London Luton Airport Expansion

8.41 Surface Access Noise Modelling Additional Information

Deadline:	Deadline 2
Planning Inspectorate Scheme Reference:	TR020001
Document Reference:	TR020001/APP/8.41
Author:	Luton Rising

Drawing Title Figure 1
Change in 2043 Do-Something - Do-Minimum Daytime LAeq,16h Surface Access Noise Contours

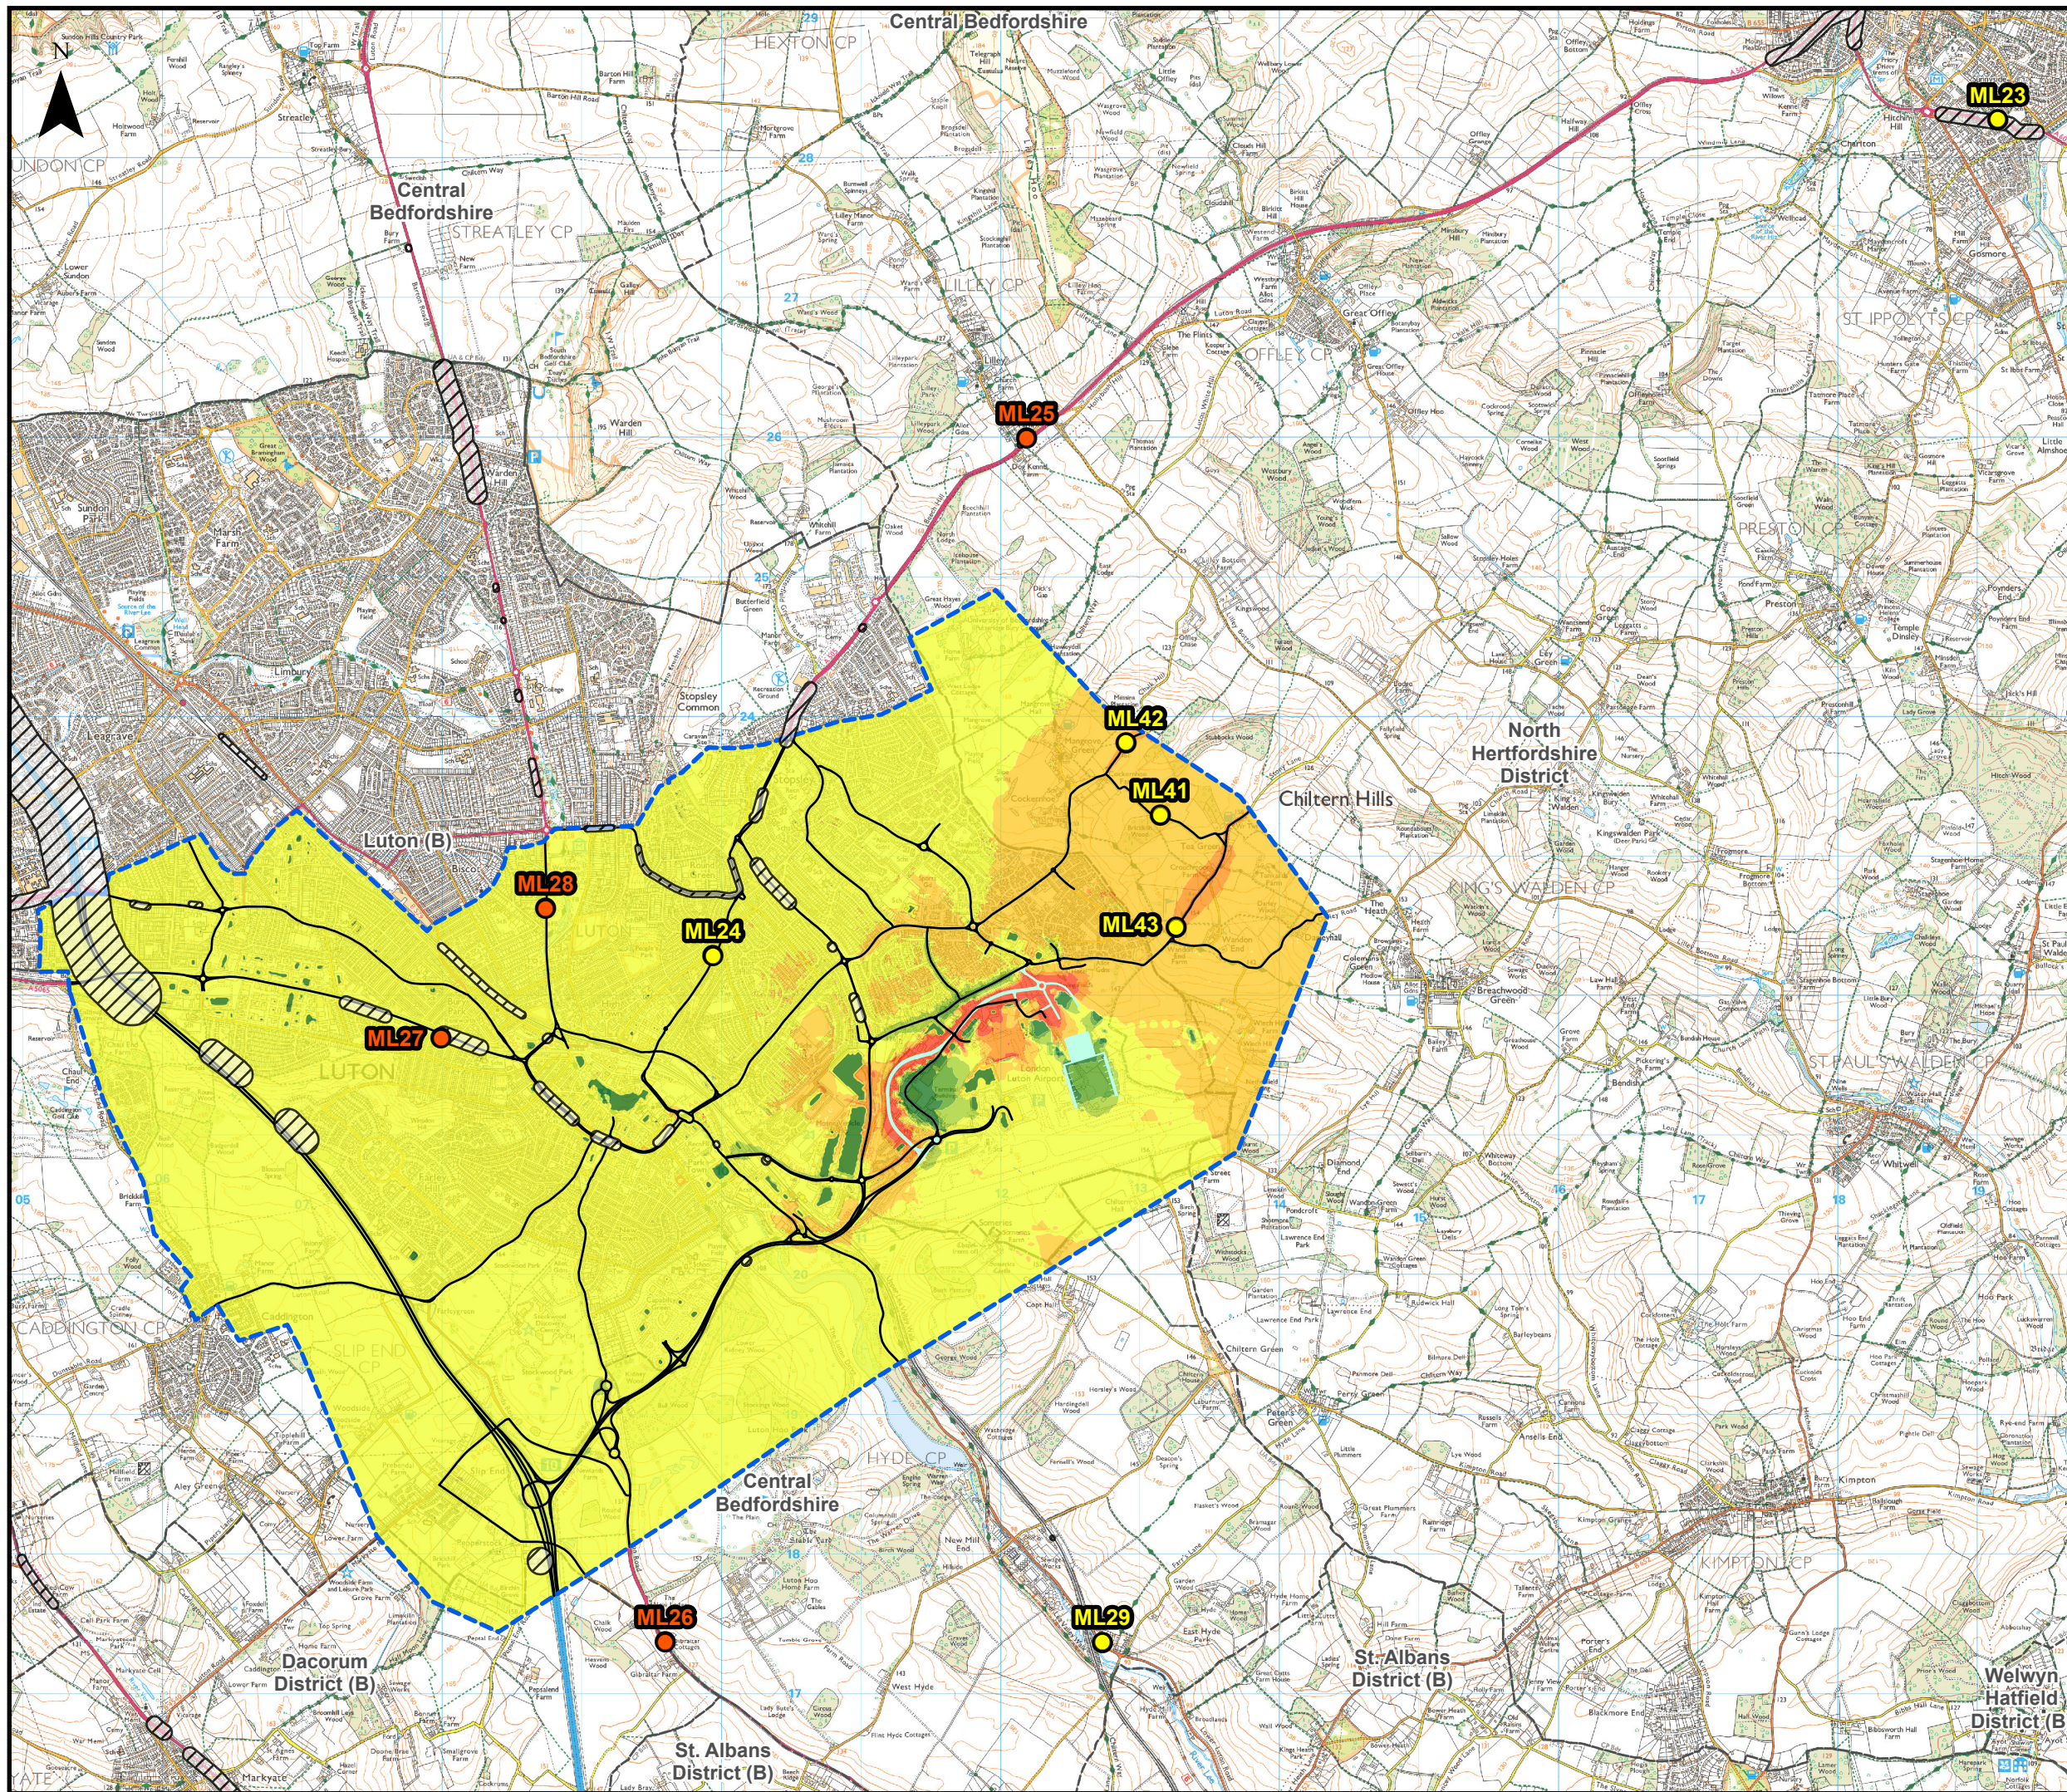
- 3.1.3 The HAs have also queried the validation of the surface access noise model, with references to instances where the measured and predicted values, with respect to the modelled baseline, differ by more than 3 dB. They recommend a clear explanation of these differences, and further justification for why the model can be relied upon.

- 4.2.4 It is noted by the HAs that at four of these 11 locations (ML25-28) the L_{Aeq,16h} derived from the measured sound levels differs by more than 3 dB from the L_{Aeq,16h} derived from the road traffic noise model.

4.2.10 Figure 1 and Figure 2 of this document show the monitoring locations overlaid on the surface access noise change contours for 2043. These figures show that the monitoring locations in question are either in areas expected to experience a negligible change in road traffic noise or outside of the surface access study area entirely². Given that localised corrections to the model would be applicable to both the Do-Minimum and Do-Something scenarios, the only change would be to absolute levels reported in the vicinity of these locations. And as explained in Section 4.1 this would not alter the conclusions of the assessment.
